Access Compliance Report

Public Rights-of-Way

(Curb Ramps)

Intersection ID: 28863	Main Street: HAMPTON_PLACE_DR	Cross Street: DELAMERE_LN	Location:	N
ADA ID: DBD9237DDD93	Ramp Type: PerpDiag	Initial Pass/Fail: Fail	Overall Compliance: No	Severity Score: 1.25
Codes/Mitigation Info/Possible Solution		Field Measurements/Component Compliance

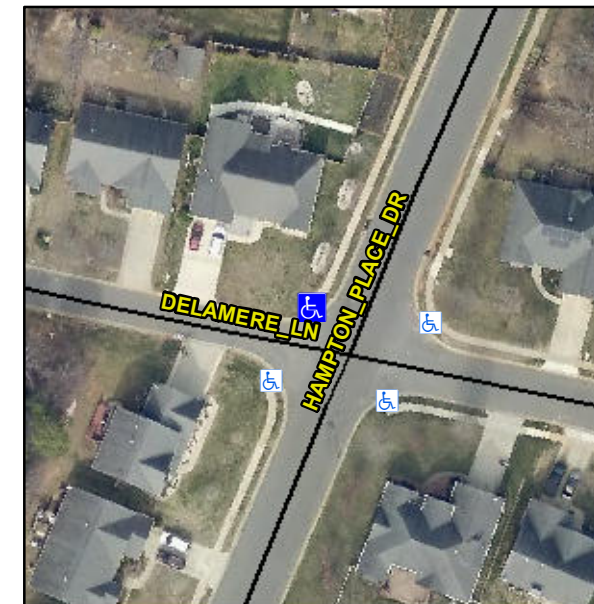
Not Found, R304.5.3

Compliance	Description	Data	Compliance	Description	Data
N/A	Ramp Length (in)	48.5	Yes	Ramp Slope (%)	6.2
Yes	Ramp Width (in)	48.0	No	Ramp XSlope (%)	2.5
N/A	Flare Type LT	N/A	N/A	Flare Type RT	N/A
N/A	Flare Slope LT (%)	N/A	N/A	Flare Slope RT (%)	N/A
N/A	Flare Traversable LT?	N/A	N/A	Flare Traversable RT?	N/A
N/A	Landing Length (in)	N/A	N/A	DWS Provided?	N/A
N/A	Landing Width (in)	N/A	N/A	DWS Contrast?	N/A
N/A	Landing Slope (%)	N/A	N/A	DWS Length (in)	N/A
N/A	Landing X Slope (%)	N/A	N/A	DWS Full Width?	N/A
N/A	Landing Curb? (Y/N)	N/A	N/A	DWS Offset (in)	N/A
N/A	Shared Landing?	N/A			
N/A	Gutter Ponding?	N/A	N/A	Gutter Slope (%)	N/A
N/A	Gutter Lip Ht (in)	N/A	N/A	Gutter X Slope (%)	N/A
N/A	Painted X Walk1?	No	N/A	Painted X Walk2?	No
	X Walk 1 Direction	To SW		X Walk 2 Direction	To SE
N/A	X Walk 1 Width (in)	N/A	N/A	X Walk 2 Width (in)	N/A
	X Walk 1 Slope (%)	1.2		X Walk 2 Slope (%)	1.1
	X Walk 1 X Slope (%)	1.9		X Walk 2 X Slope (%)	0.7

Remove & Replace Curb Ramp With Two New Directional Ramps or Equivalent.
